STAFF REPORT

CASE NUMBER: P.D. 08-336 **L.U.C.B. MEETING:** February 12, 2009

DEVELOPMENT: MEMPHIS HOMEBUILDERS' CENTER PLANNED DEVELOPMENT, Amended

REQUEST: Plan amendment to allow Planned Commercial(C-P) District land uses, including a restaurant, retail center and a three(3) story hotel building.

OUTLINE/CONCEPTUAL PLANS

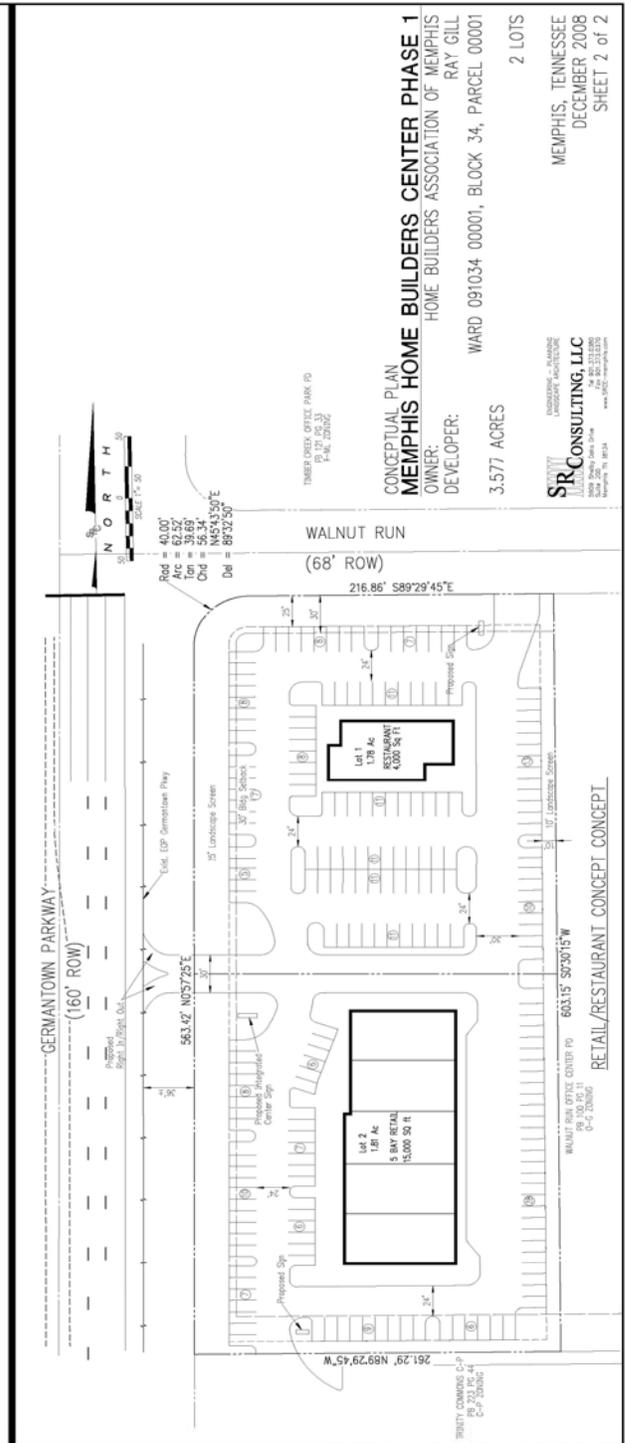
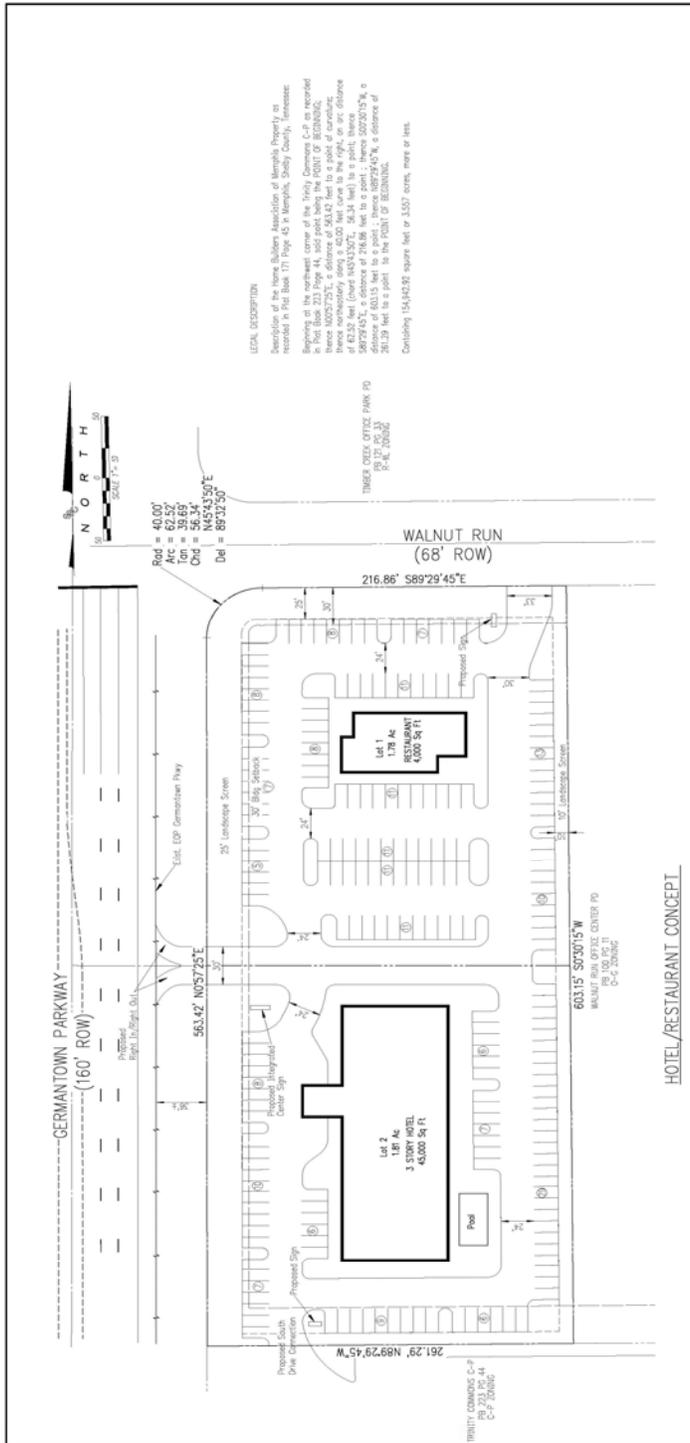
3. The applicant has since requested a maximum height of sixty(60) feet or four(4) stories for the hotel building proposed at the south end of the property. This planned development was originally approved and developed for the General Office(O-G) District zoning.

4. The applicant is also requesting a right-in/right-out curb-cut midpoint of the parcel to allow primary access and internal circulation at the south-end with Trinity Commons Shopping Center. The traffic patterns and good planning practice warrants internal circulation between adjacent parcels so long as the parties agree.

Fire Station 58 is south of the parcel and respond, most likely, onto the right-in, right-out access point at the south side of the buildings. The width is shown as 16.5'. Is this typical? What signage, if any, would violate the 20' clearance required for fire access?

- I. Use Permitted:
 - A. Any use permitted by right in the O-G General Office District.
 - B. *Any use permitted by right and administrative site plan review in Planned Commercial(C-P) District, including a four(4) story hotel building.*

- II. Bulk Regulations:
 - A. Minimum building setbacks:
 - 1. Germantown Parkway – 42 feet
 - 2. Walnut Run Road and Timber Creek Drive – 30 feet
 - 3. South property line – 35 feet
 - B. Maximum building height – 35 feet *and sixty(60') feet for a hotel building.*
